Engine vibrations perceived at low rpm -
Camshaft adjustment fault codes stored

Topic number	LI05.20-P-080329
Version	1
Function group	05.20 - Camshaft, camshaft adjustment
Date	3/2/26
Validity	M254 engine in all model series
Reason for change	Replaces LI05.20-P-080257

Fehlendes Sieb des Zentralventils.jpg

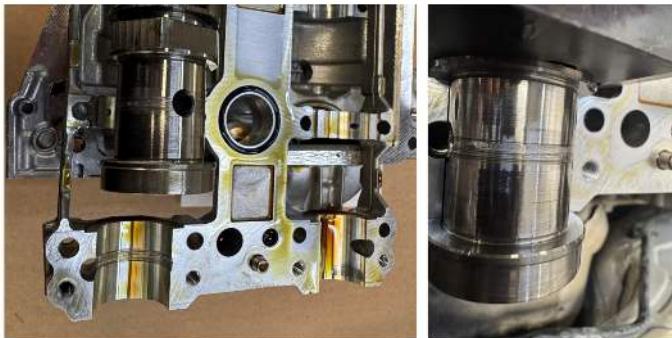
The screen has almost completely broken out

Continuously fluctuating oil pressure in the central valve may lead to damage to the filter screen on the central valve. This can result in damage to the filter screen or the filter screen breaking loose.

If the filter screen breaks loose, parts of it may settle in the camshaft adjuster or in the camshaft. If there are parts in the camshaft, they can pass through the oil supply bore to the last camshaft bearing (i.e., the first camshaft bearing behind the adjuster) which could cause damage there.

2. In cases where the sieve is completely/partially missing and metal particles are found in the oil filter, the camshaft bearings must be checked. If any damage is visible there, proceed as follows:

- Both central valves
- The camshaft adjuster of the damaged central valve
- The camshaft bearing housing (camshafts are already included here)
- Oil change with oil filter
